TO: Daron Haddock, Permit Supervisor

FROM: Rick P. Summers, Senior Hydrologist *RS*

RE: Review: Demonstration of Design Event Exceedance (received September 6, 1991), Belina Mine Complex, Valley Camp Coal, Inc., ACT/007/001, Carbon County, Utah

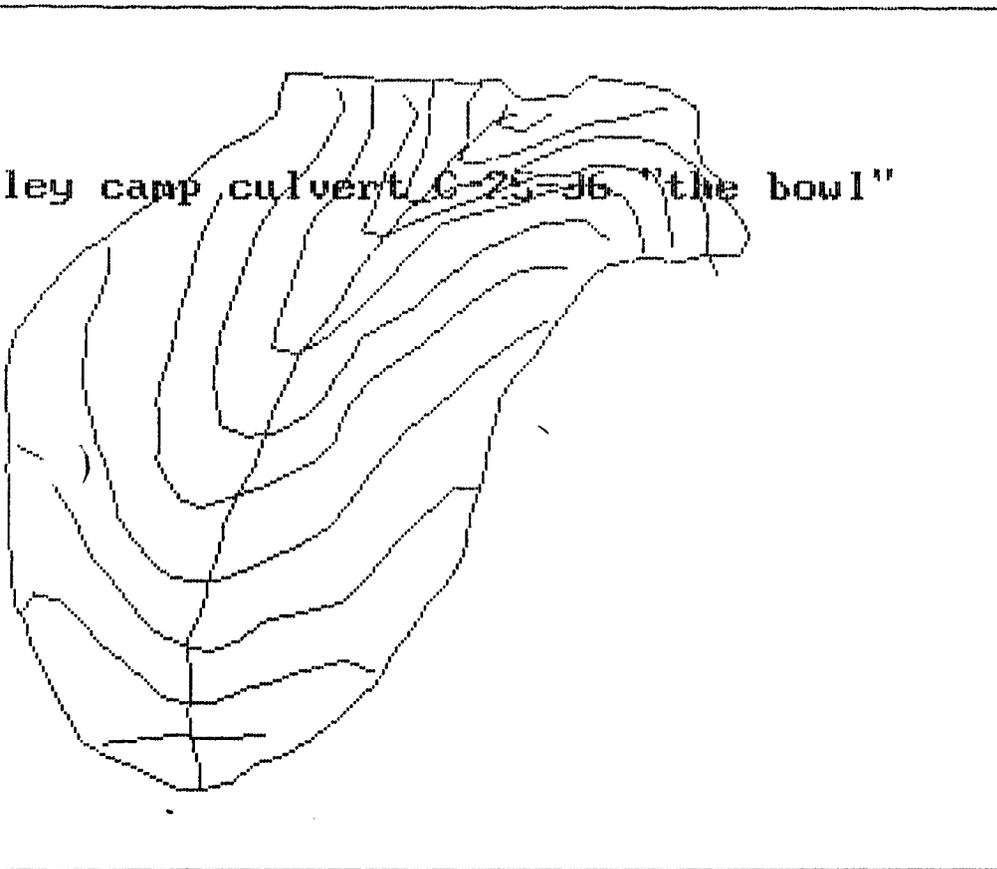
As a side note, the reader may be curious as to why the design flow storm was exceeded by such a significant degree. Also, it became interesting to note the comparison between an actual event and the predicted event. It is apparent that the selection of the curve number is of paramount importance for these small duration, high intensity storms and watersheds with a high moisture content. Using a CN of 73 as the design value for one watershed (C-25-36) and a 0.76"/20 minute storm, the SCS hydrograph model predicts a flow of 0.05 cfs. The actual measured flow at this site was on the order of 30 cfs. Examination of this problem (in addition to the potential sources of error noted previously) indicates that by using a curve number with a high soil moisture adjustment (AMC III, CN=83), the model predicts the peak flows a bit more accurately. Using a CN of 83 and identical watershed/storm assumptions the predicted flow value for this short duration storm is on the order of 23 - 28 cfs (depending on the storm distribution used). Additional occurrences of this type of storm and related failures may warrant Division modification of the design storm criteria and procedure for peak flow determination.
